SERVICE BULLETIN

INSPECTION FOR CORRECT VENTING OF THE OIL SYSTEM FOR ROTAX® ENGINE TYPE 912 AND 914 (SERIES)

SB-912-036 R1

SB-914-022 R1

See fig. 1, 2, 3, 4 and 5

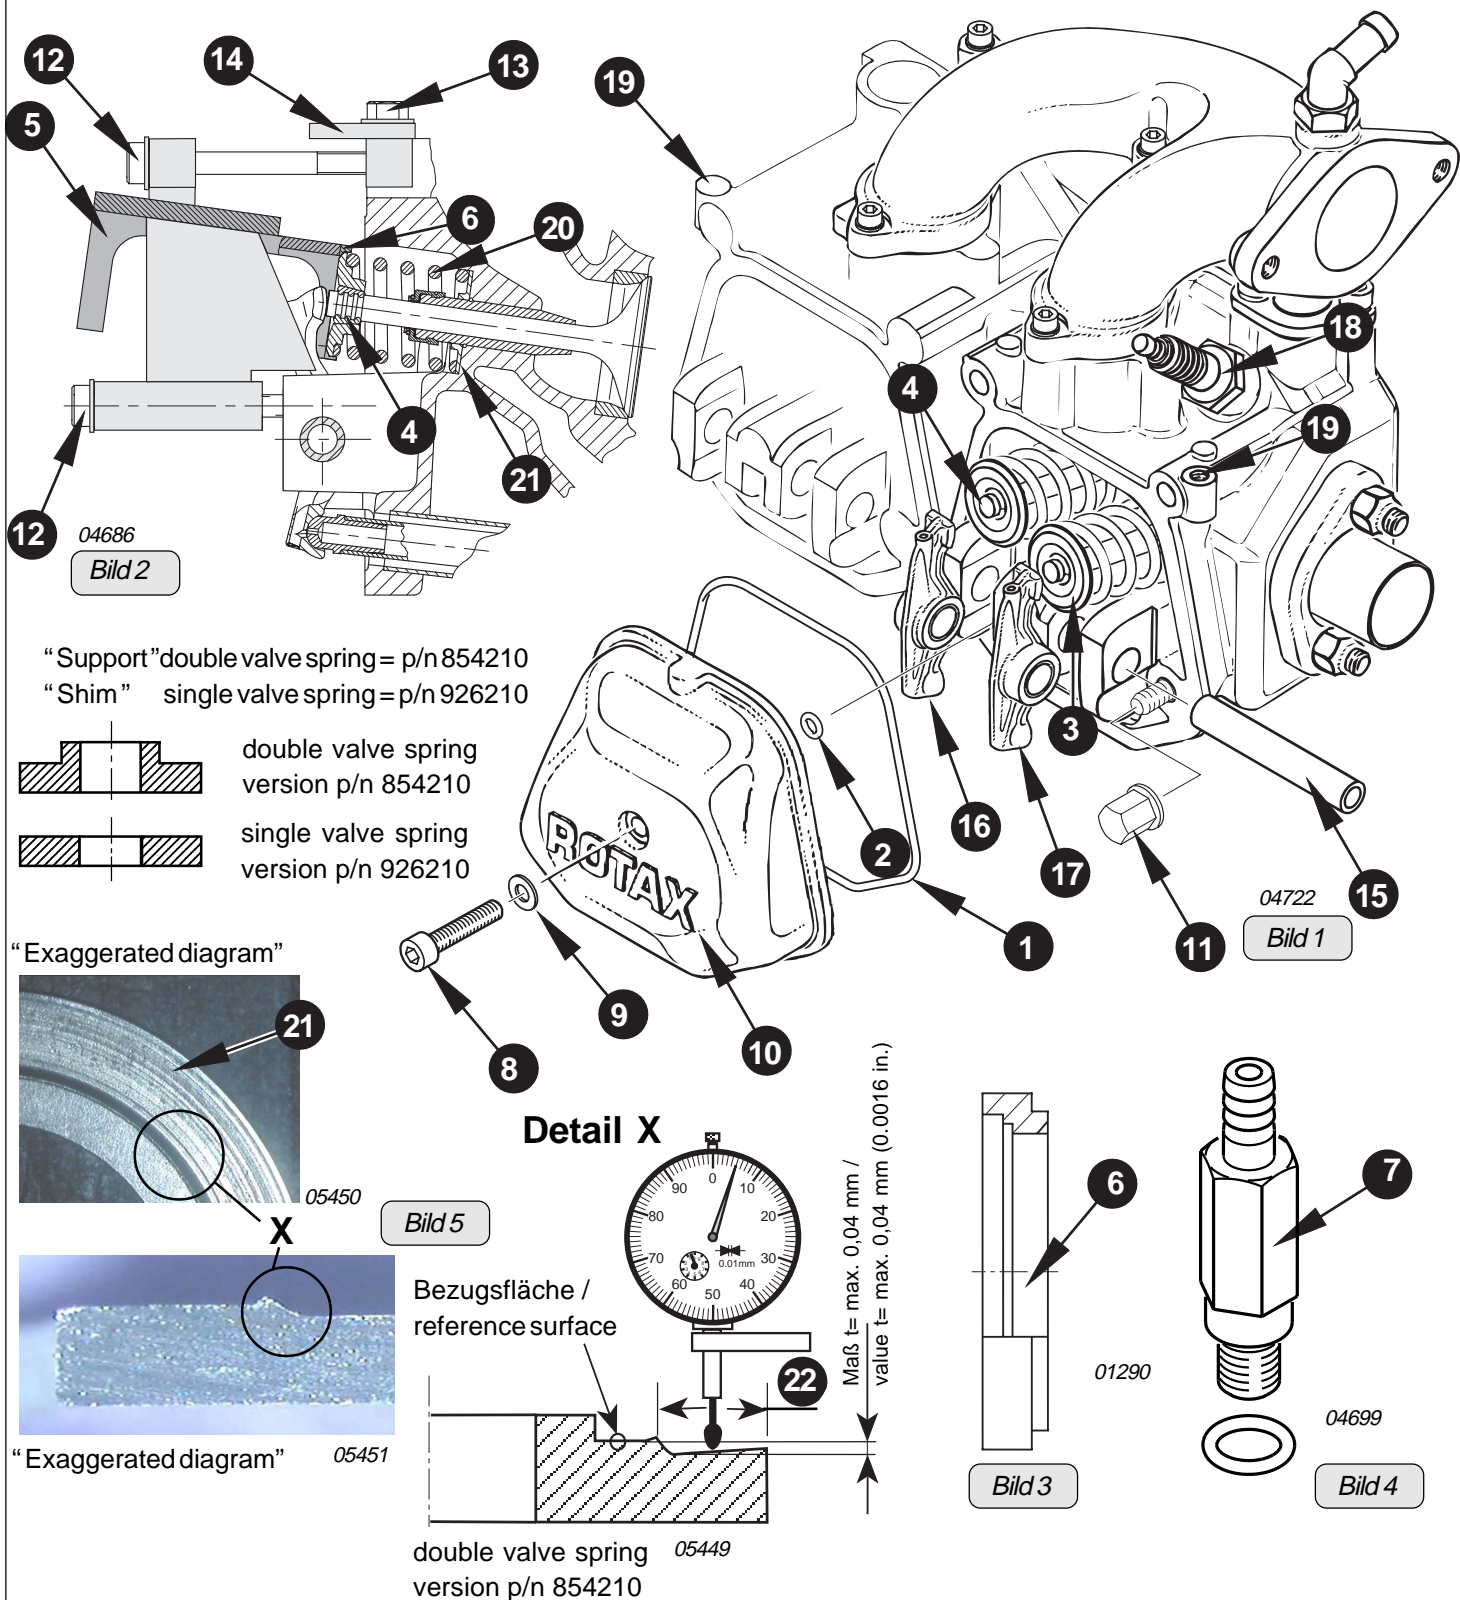
- Remove Allen screw (8) M6x30 with washer (9) from valve cover (10).

- Remove large and small O-ring (1) and (2).

- Remove the external cap nut (11) (exhaust side of cylinder).

- Attach the support plate (14) for the valve spring loading jig (5) with 2 hex. screws (13) M6x16 at the attachment points (19) on the cylinders.

- Attach the valve spring loading jig on cylinder head and support plate with 2 Allen screws (12) M6x70.

- Fit the screw nipple (7) into the spark plug hole.

- Depress the 2 valve spring evenly by the valve spring loading jig (5) until the valve cotters are easily accessible. Simultaneously both hydraulic tappets will be relieved.

- Remove rocker arm shaft (15).

- Remove both rocker arms (16) and (17).

- Remove the valve cotters (4).

- Inspect valve spring support (21). Measure the wear referring to the reference surface (inner area of valve spring support) in radial direction to outer side with a dial gauge. Value $t = \max. 0,04 \text{ mm} (0,0016 \text{ in.})$. See fig. 5. An exceeding of $\max. 0,04 \text{ mm} (0,0016 \text{ in.})$ is not acceptable. Any exceeding of this limit requires a complete replacement of valve spring support, valve spring retainer, valve cotters and hydraulic valve tappets or any other damaged components on the affected valve train.
